BULLETIN NO. 33

JEFFERSON LAB

TECHNICAL ENGINEERING & DEVELOPMENT FACILITY
(TEDF TWO)

Bulletin No.33
Project No. 20080400
March 04, 2011

8 SECTION DETAIL
3" = 1'-0"

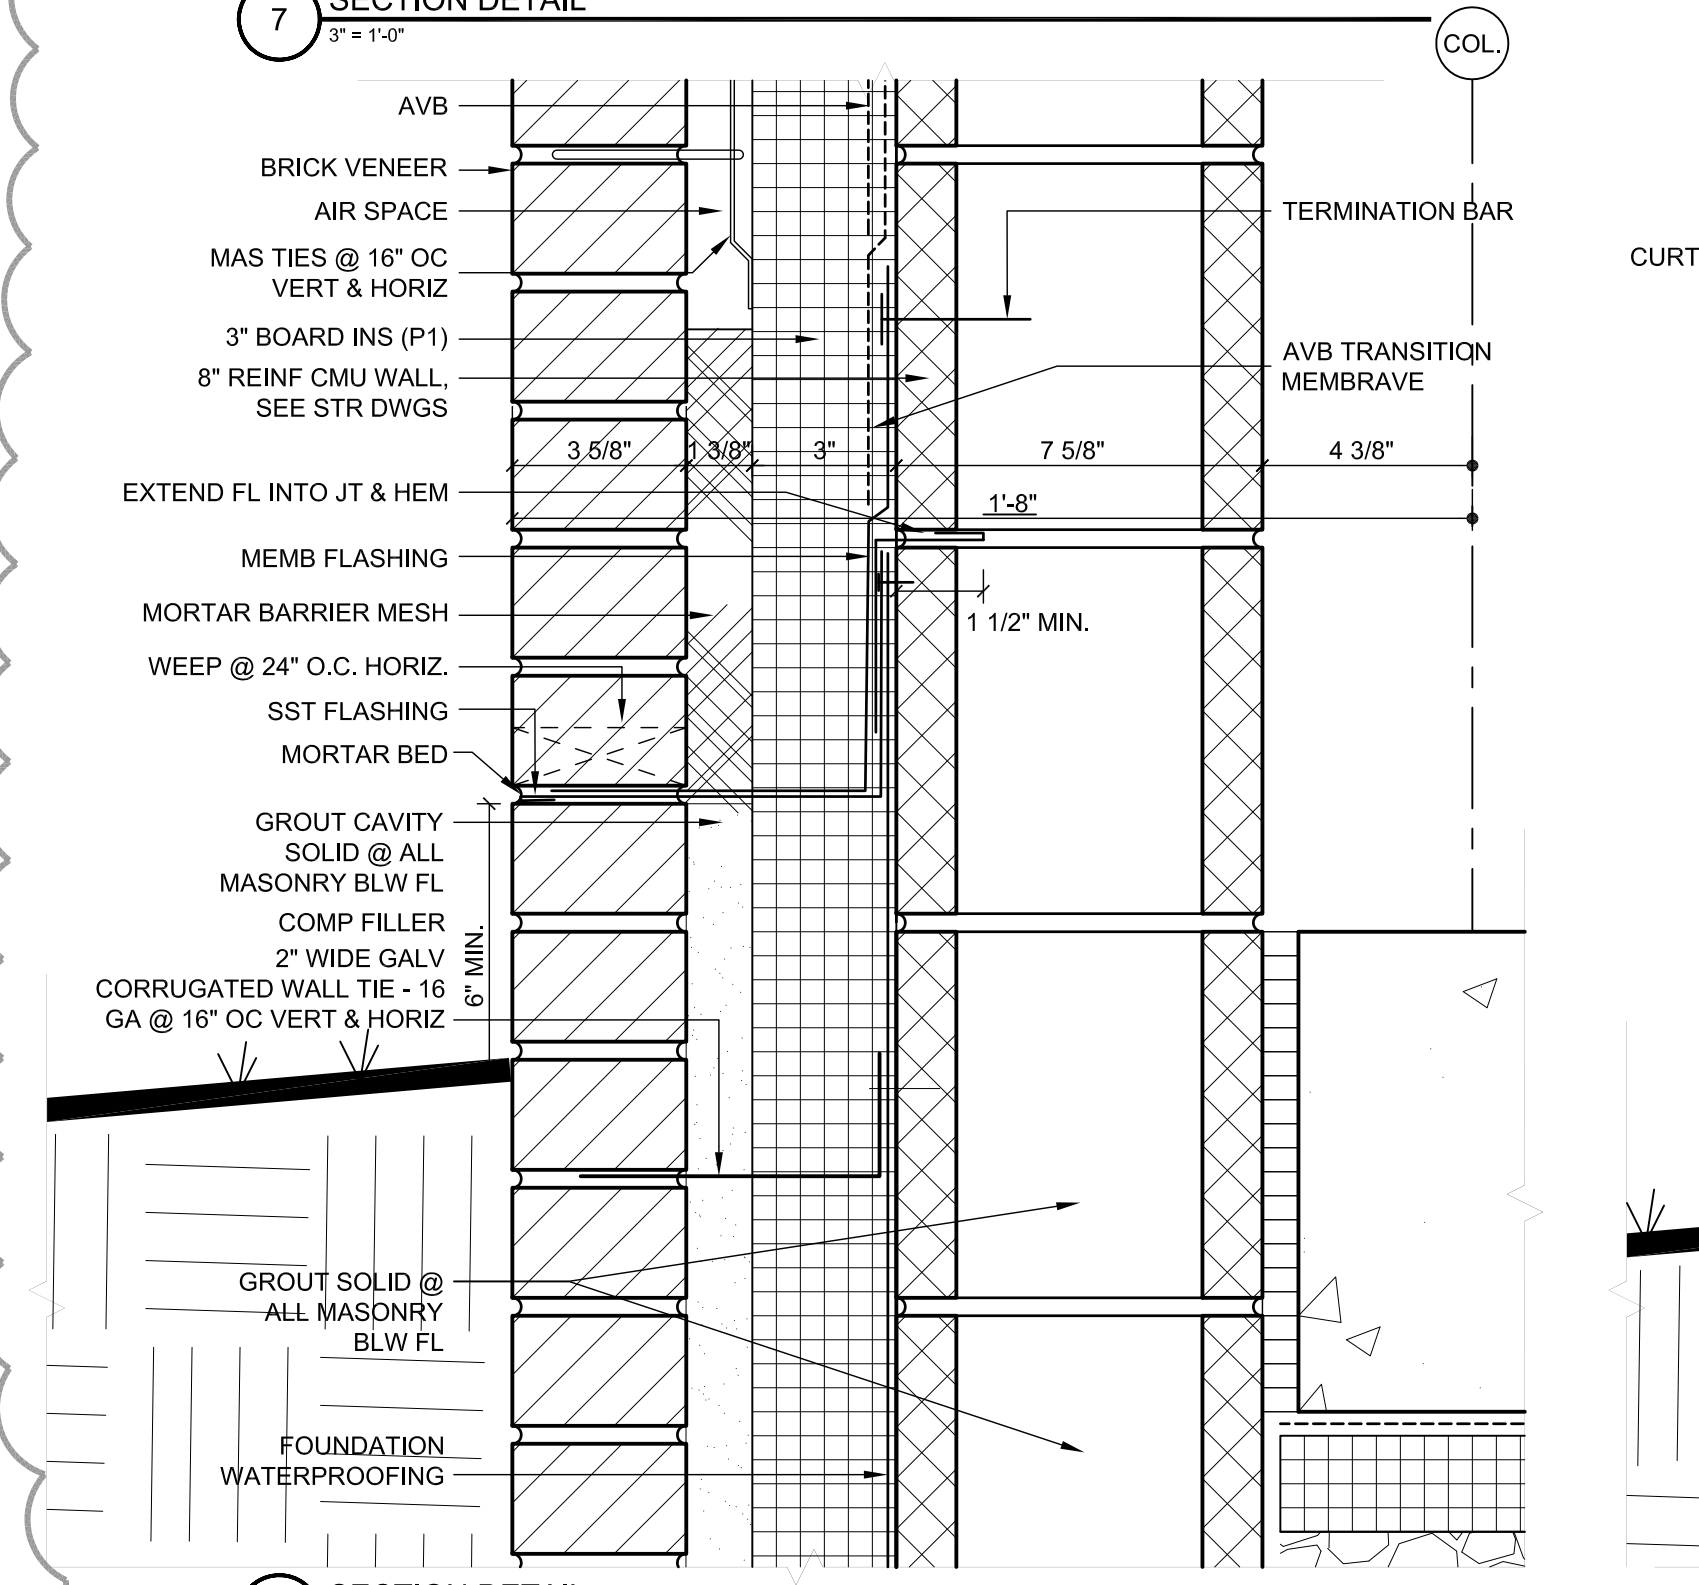
1. Revised section details

SCALE	DRAWING NUMBER	SHEET	REV
3" = 1'-0"	100024-180-A162-STE	TED-A3.2.4.3	-

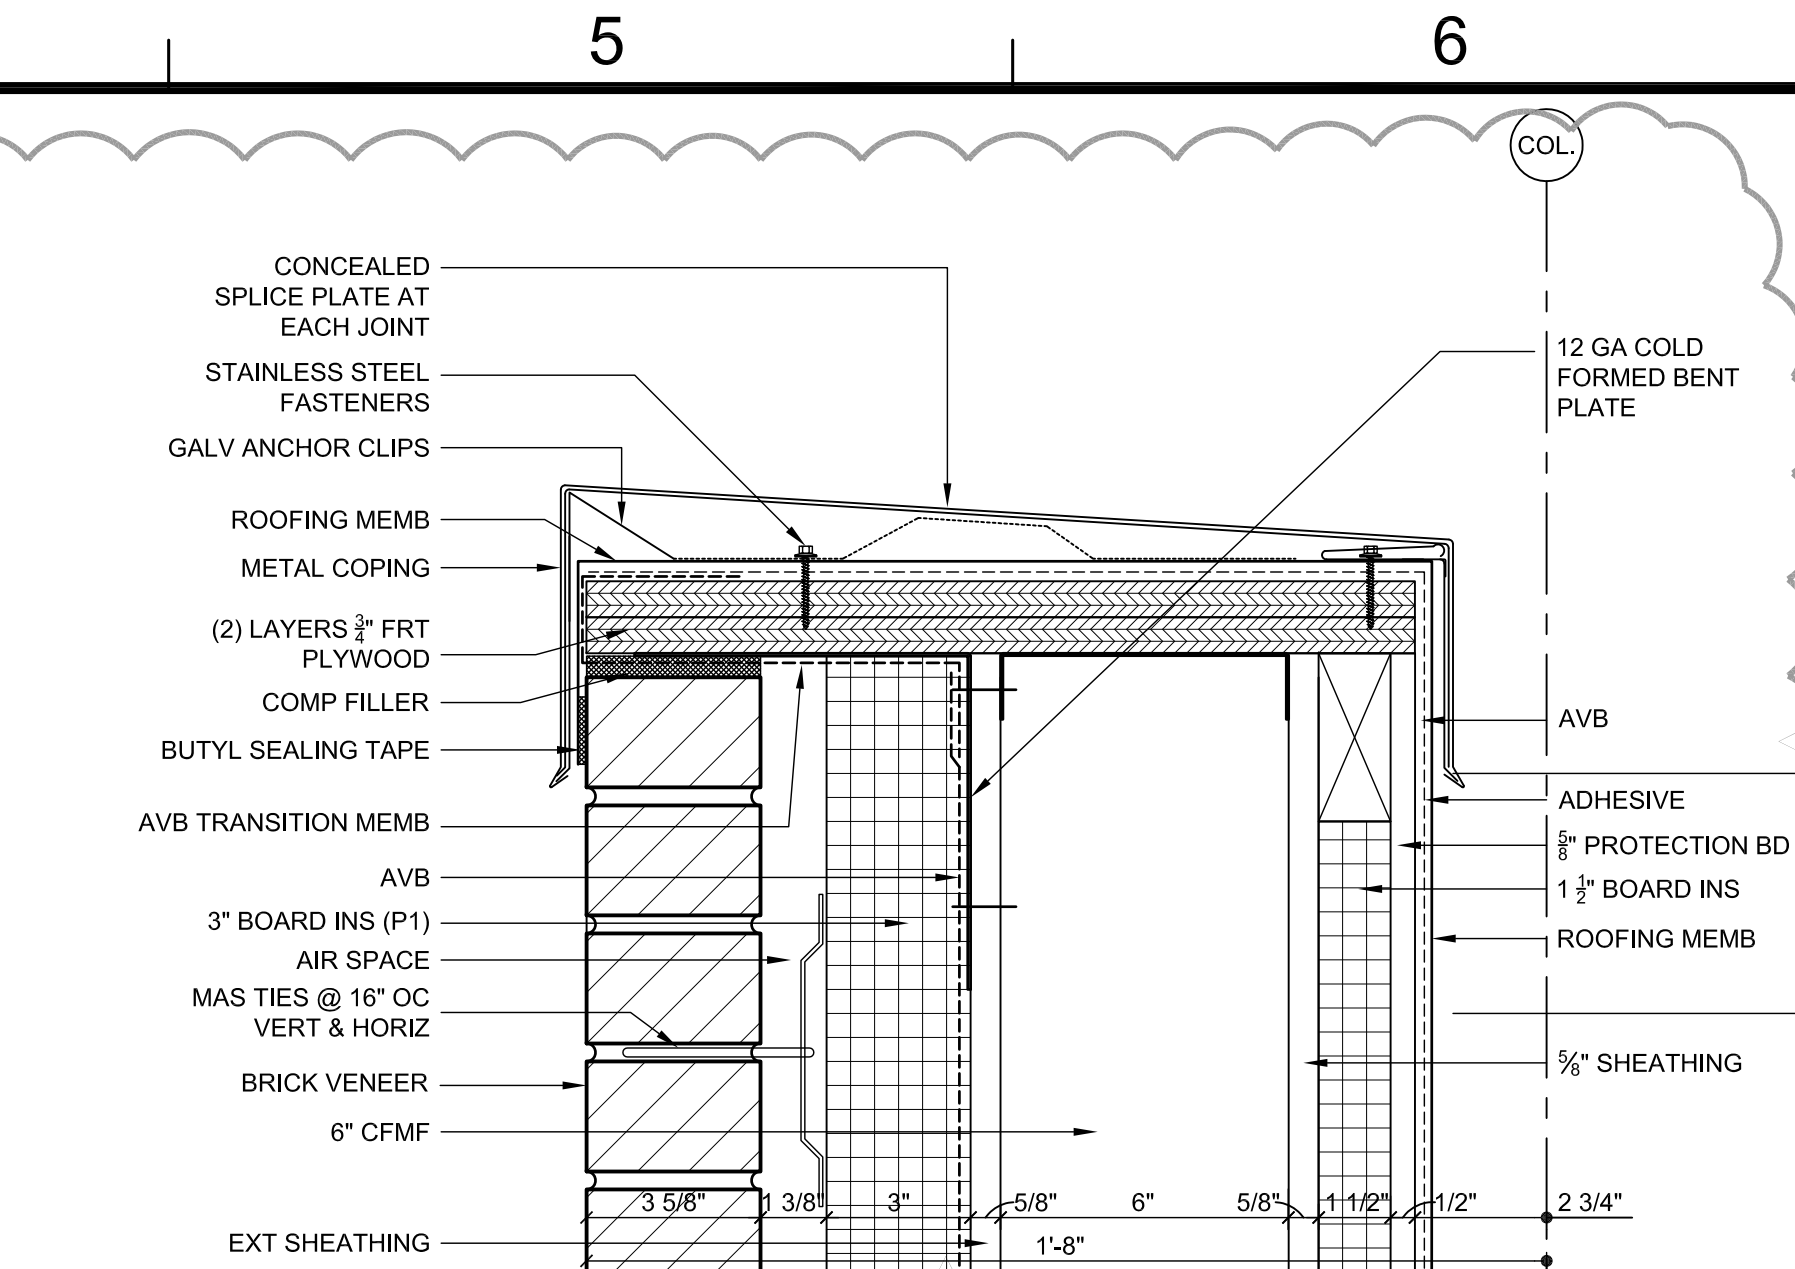
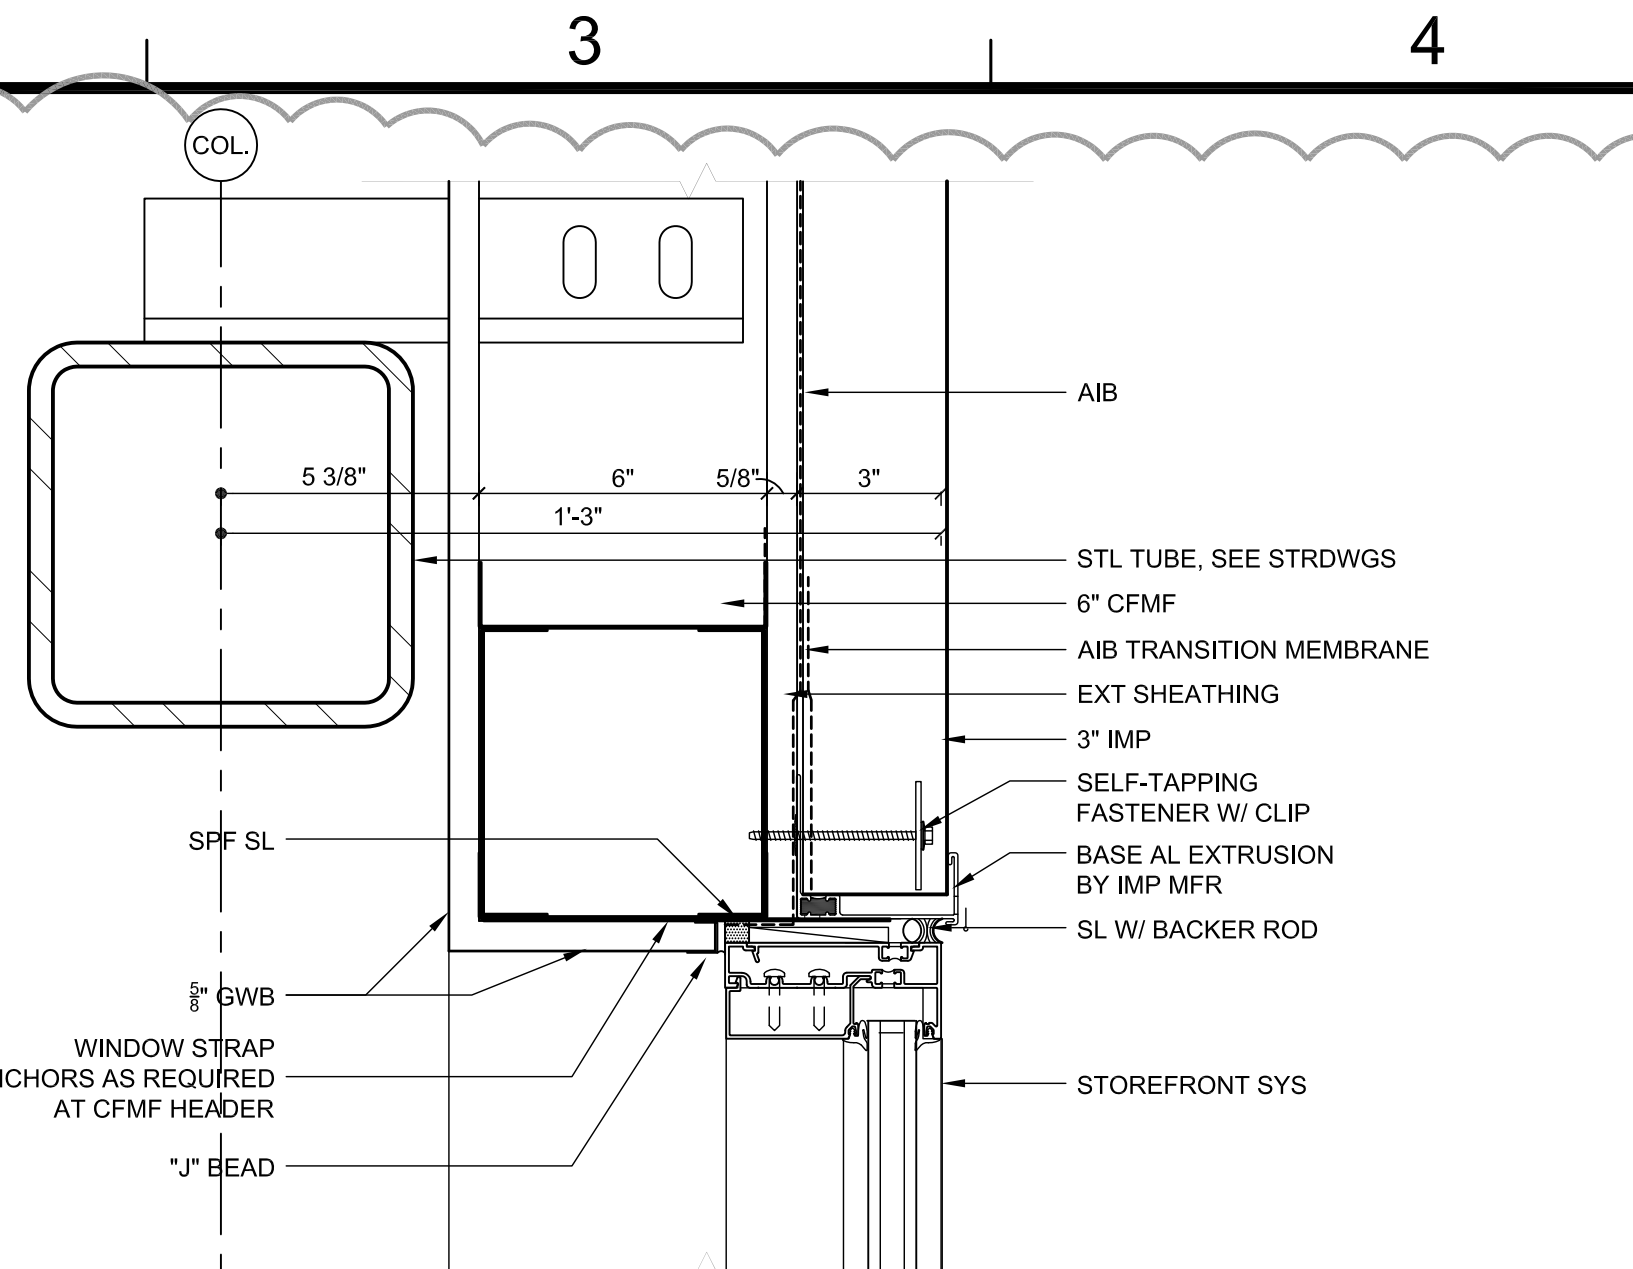
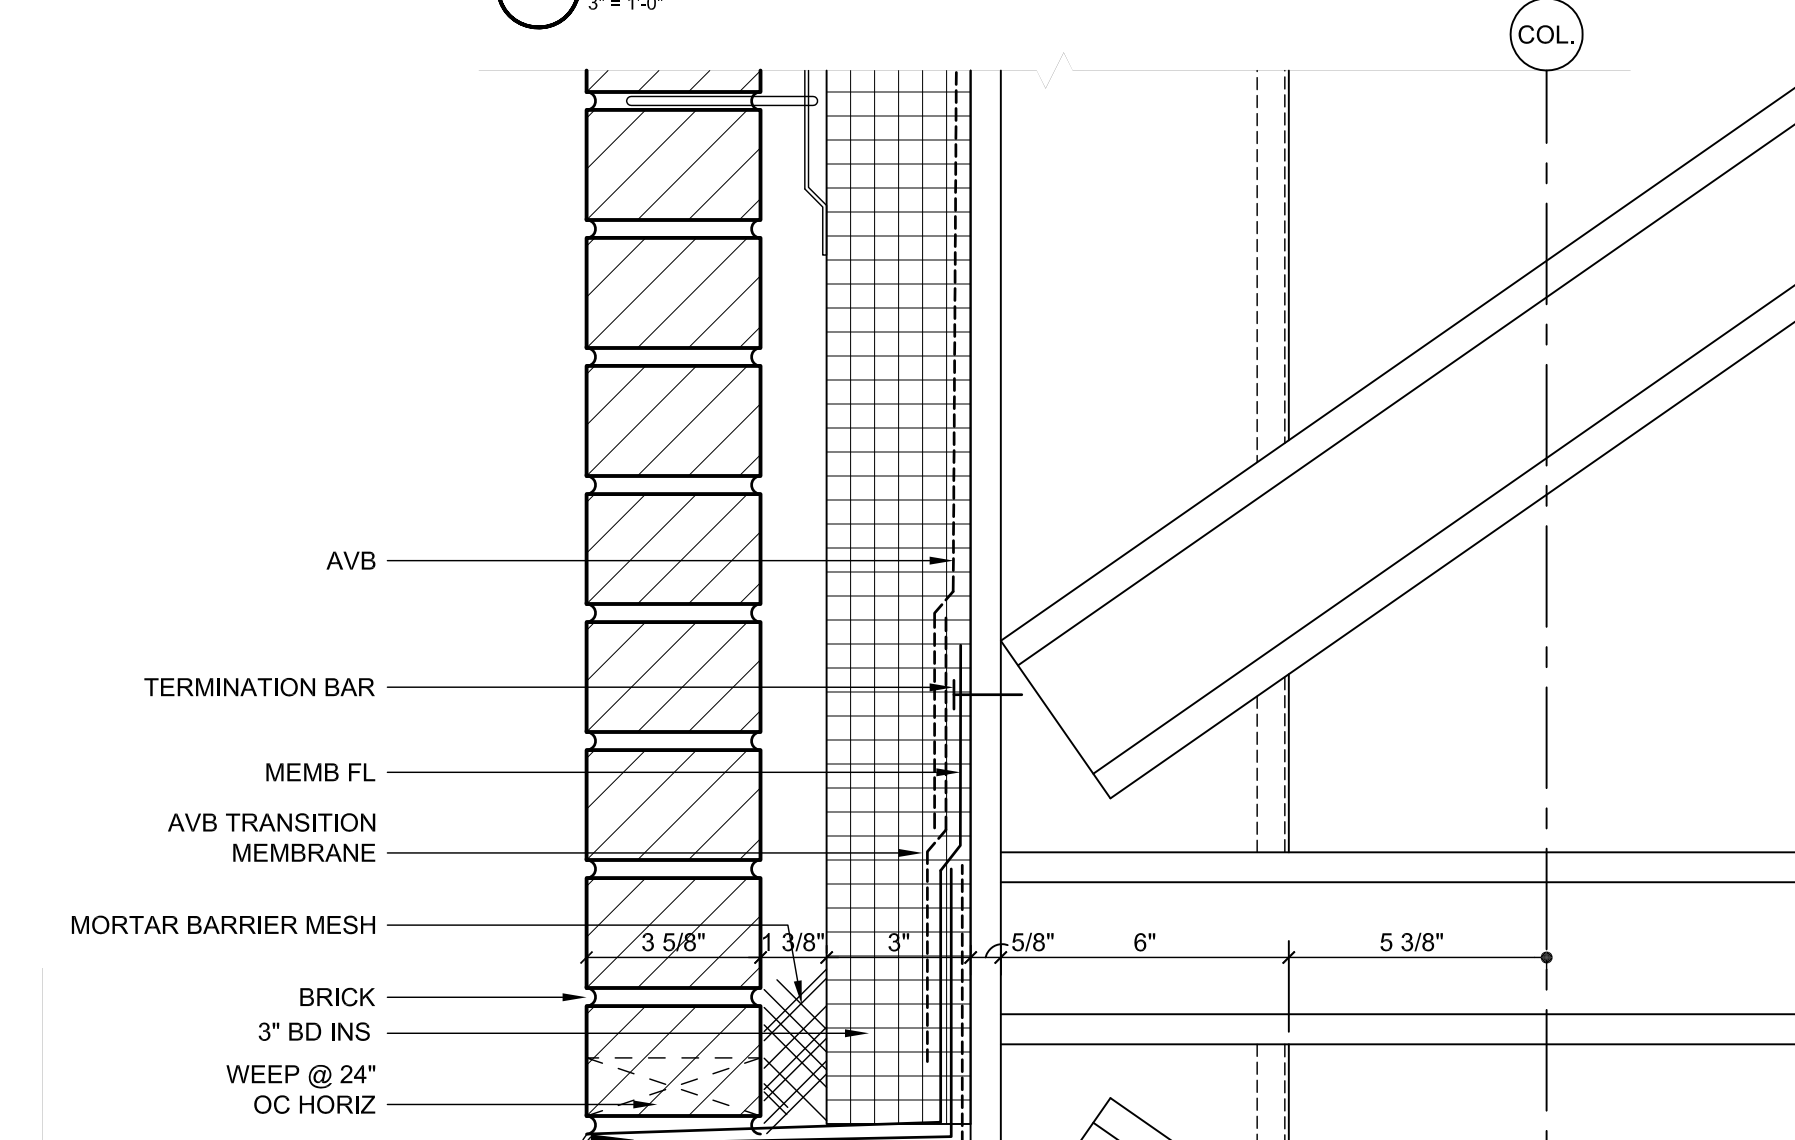
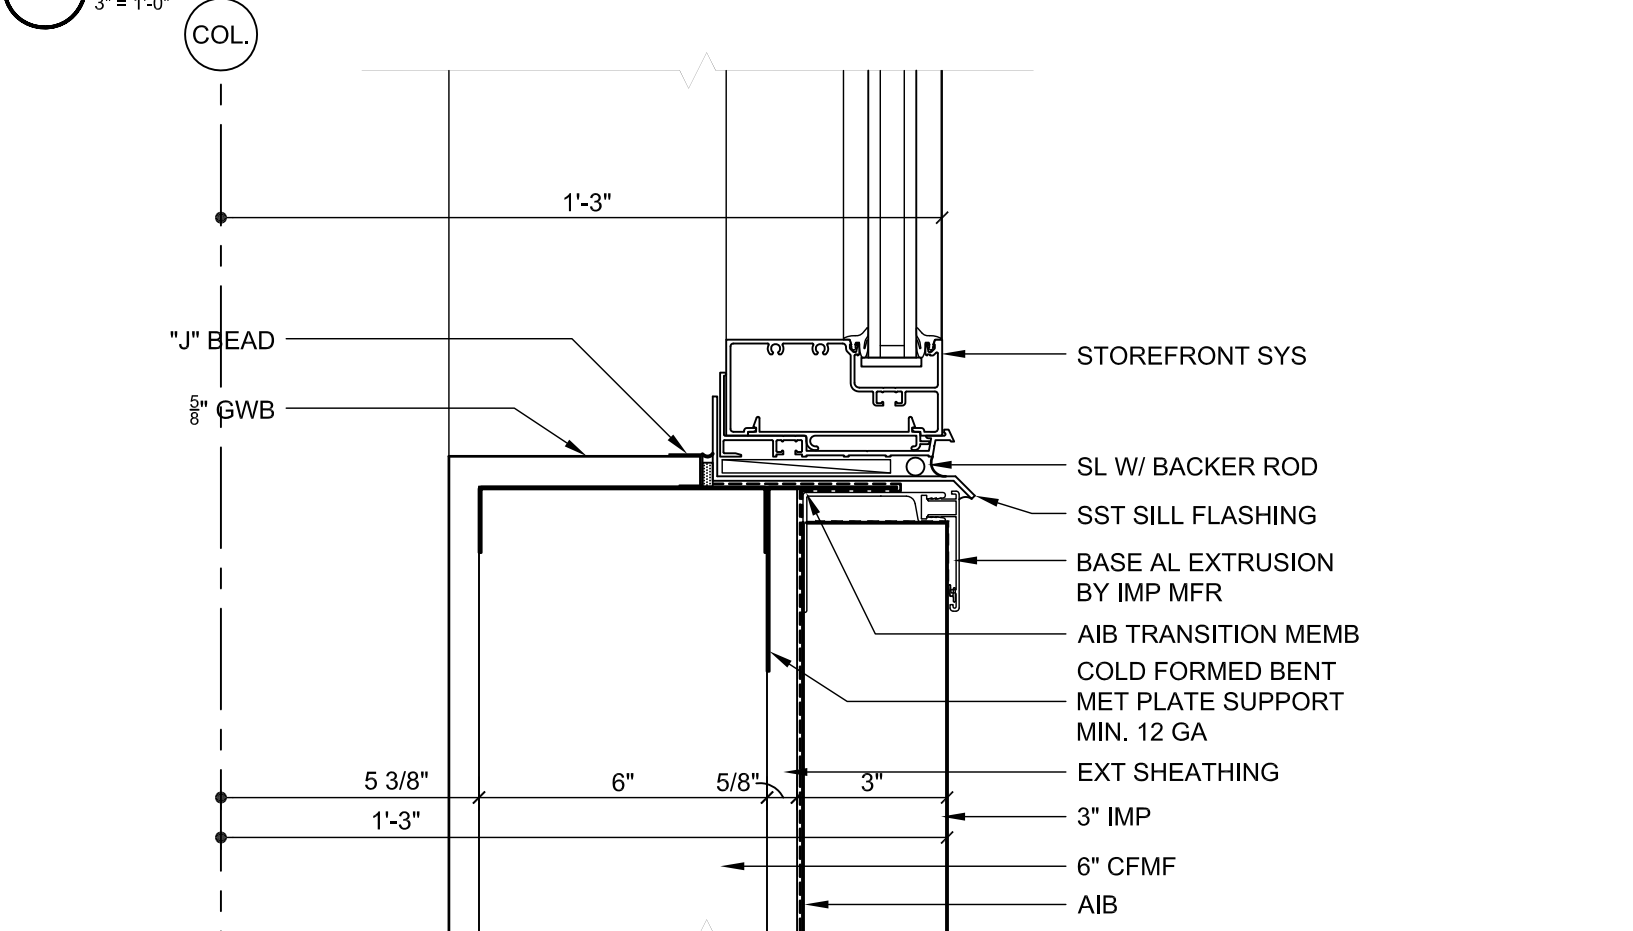
1. Revised section details
